Joint Meeting of Experts on the Regulations annexed to the European Agreement concerning the International Carriage of Dangerous Goods by Inland Waterways (ADN) (ADN Safety Committee)

Report of the Joint Meeting of Experts on the Regulations annexed to the European Agreement concerning the International Carriage of Dangerous Goods by Inland Waterways (ADN Safety Committee) on its thirty-sixth session*

Addendum

Proposed amendments to the Regulations annexed to ADN for entry into force on 1 January 2021

Type G Cargo tanks design 2
Type of cargo tank 4”.

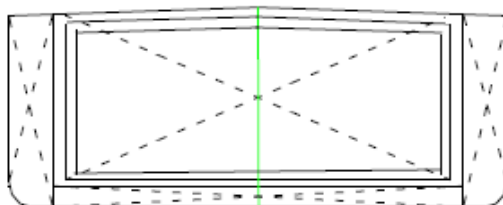
1.2.1 Amend the definition for *Type of vessel* as follows:

Amend the entry for “Type G” to read as follows:

“Type G: means a tank vessel intended for the carriage of pressurized or refrigerated gases.”

In the Sketches section, add the following Type G sketch:
